# Access Compliance Report

## Public Rights-of-Way

Intersection ID: 19012	Main Street: DEVERON_DR	Cross Street: RAMA_RD	Location: SW
ADA ID: 38FEA98F88B8	Ramp Type: PerpDiag	Initial Pass/Fail: Fail	Overall Compliance: No
Codes/Mitigation Info/Possible Solution		Field Measurements/Component Compliance	
Severity Score: 22.5

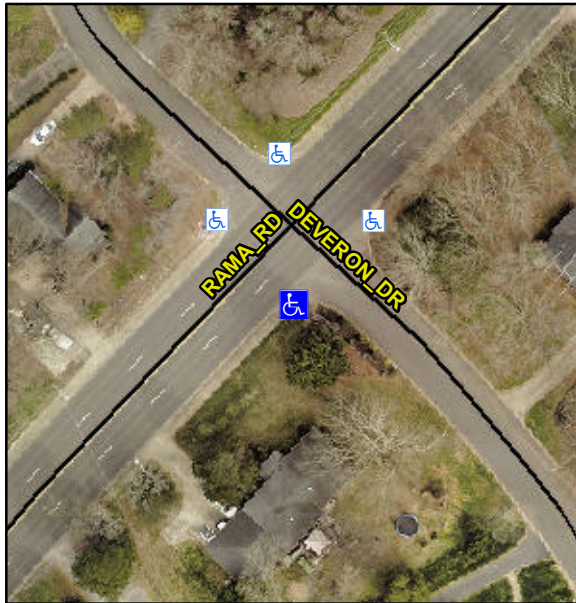
**Not Found, R304.5.1, R304.2.2, R304.5.3**

Compliance	Description	Data	Compliance	Description	Data
N/A	Ramp Length (in)	60.5	No	Ramp Slope (%)	9.2
No	Ramp Width (in)	36.5	No	Ramp XSlope (%)	3.5
N/A	Flare Type LT	N/A	N/A	Flare Type RT	N/A
N/A	Flare Slope LT (%)	N/A	N/A	Flare Slope RT (%)	N/A
N/A	Flare Traversable LT?	N/A	N/A	Flare Traversable RT?	N/A
N/A	Landing Length (in)	N/A	N/A	DWS Provided?	N/A
N/A	Landing Width (in)	N/A	N/A	DWS Contrast?	N/A
N/A	Landing Slope (%)	N/A	N/A	DWS Length (in)	N/A
N/A	Landing X Slope (%)	N/A	N/A	DWS Full Width?	N/A
N/A	Landing Curb? (Y/N)	N/A	N/A	DWS Offset (in)	N/A
N/A	Shared Landing?	N/A			
N/A	Gutter Ponding?	N/A	N/A	Gutter Slope (%)	N/A
N/A	Gutter Lip Ht (in)	N/A	N/A	Gutter X Slope (%)	N/A
N/A	Painted X Walk1?	No	N/A	Painted X Walk2?	No
	X Walk 1 Direction	To NE		X Walk 2 Direction	To NW
N/A	X Walk 1 Width (in)	N/A	N/A	X Walk 2 Width (in)	N/A
	X Walk 1 Slope (%)	3.1		X Walk 2 Slope (%)	4.1
	X Walk 1 X Slope (%)	0.0		X Walk 2 X Slope (%)	3.1

**Remove & Replace Curb Ramp With Two New Directional Ramps or Equivalent.**
